## URBAN DESIGN GUIDELINES FOR BULK OF BUILDINGS

## MAP APPROVED BY THE BOARD OF SUPERVISORS

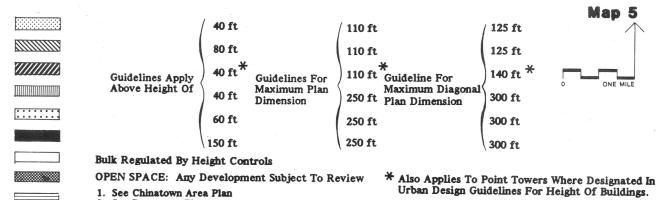
- → Add a boundary around the Visitacion Valley Schlage Lock area with a line that leads to a reference that states "See Redevelopment Plan for the Visitacion Valley Schlage Lock Project. (BOS Ordinance 0072-09)

- → Insert boundary around Cp and refer to the CP Subarea Plan and BVHP and Redevelopment Plan; revise notation about HPS to refer to the HPS Area Plan as well as the HPS Redevelopmet Plan. (BOS Ordinance 0203-10)

- → Insert diagram to show Treasure Island and Verba Buena Island. Add a boundary around Treasure Island and Yerba Buena Island and refer to the TINBI Area Plan and applicable Design for Development. (BOS Ordinance 0097-11)

- → Add a boundary around Executive Park and refer to the Executive Park Subarea Plan of the Bayview Hunters Point Area plan. (BOS Ordinance 0143-11)
- → In legend, amend text to read: "2. See Downtown Plan including Transit Center District Sub-Area Plan." (BOS Ordinance 0185-12)

- → Change the maximum plan dimensions and maximum diagonal plan dimensions for the proposed St. Luke's Campus Hospital site from 110' and 125', respectively, to 229' and 285', respectively, and to change the maximum plan dimensions and maximum diagonal plan dimensions for the proposed St. Luke's Campus Medical Office Building site from 110' and 125', respectively, to 204' and 228', respectively, as those sites are described in the California Pacific Medical Center's Long Range Development Plan. (BOS Ordinance 0146-13)

- → Change the bulk limits for the site identified for the proposed Cathedral Hill Campus Hospital (Block 0695/Lots 005, 006 and their successor Blocks and Lots) from a maximum plan dimension of 110' and maximum diagonal plan dimension of 140' to a maximum plan dimension of 385' and maximum diagonal plan dimension of 466', and to change the bulk limits for the site identified for the proposed Cathedral Hill Campus Medical Office Building (Block 0694/Lots 005, 006, 007, 008, 009, 009A, 010 and their successor Blocks and Lots) from a maximum plan dimension of 265' and maximum diagonal plan dimension of 290'. (BOS Ordinance 0145-13)

- → Add a reference that states, "See Fifth and Mission Special Use District, Section 249.74 of the Planning Code, for buildings therein." (BOS Ordinance 0207-15)

- → Delete Assessor's Block 5952, Lot 002 from the shaded portion and add a note that states "See Jewish Home of San Francisco Special Use District, Planning Code Section 249.73, and San Francisco Zoning Map SU011." (BOS Ordinance 0186-15)

- → Add a reference that states, "See Pier 70 Mixed-Use Project Special use District, Section 249.79 of the Planning Code, for buildings therein." (BOS Ordinance 0227-17)

- → Change Lot 1 in Assessor's Block 766 as follows: the guidelines shall apply above a height of 150 feet with a maximum plan dimension of 250 feet and a maximum diagonal dimension of 300 feet. (BOS Ordinance 0209-01)

- → Delete the shaded areas within the Mission Bay area and add a boundary around the Mission Bay area with a line that leads to a reference that states "See Mission Bay North and Mission Bay South Redevelopment Plans." For Assessor's Blocks 3796 (Lots 1 and 2), 3797(Lot 1), and a portion of 3880, place a "t" (cross shape) on the parcels with a similar "t" on the bottom of the page that states "See the Mission Bay Guidelines adopted by the Planning Commission"

- → Add a boundary area around the Hunters Point Shipyard area with a line that leads to a reference that states "See Hunters Point Redevelopment Plan and Hunters Point Shipyard Area Plan"

- → Add reference under #2 to Transbay: See Downtown Plan and Transbay Redevelopment Development Controls and Design for Development Plan
- → Delete shadings, add + at AB3796 (lots 1&2), 3797 (lot 7) and part of 3880; and add: "See Mission Bay North and South Redevelopment Plans"

- → Add a boundary area around Candlestick Point with a line that leads to a reference that states "See Candlestick Point SubArea Plan and Bayview Hunters Point Redevelopment Plan"

- → Add + under "\*Also Applies..." and add: "See Mission Bay Guidelines adopted by the Planning Commission"
- → Add a boundary area around the Balboa Park Station plan area with a line that leads to a reference that states "See the Balboa Park Station Area Plan"

- → Add a boundary area around the Visitacion Valley Schlage Lock area with a line that leads to a reference that states "See Redevelopment Plan for the Visitacion Valley Schlage Lock Project"

- → Add a boundary area around Executive Park with a line that leads to a reference that states "See Executive Park SubArea Plan"
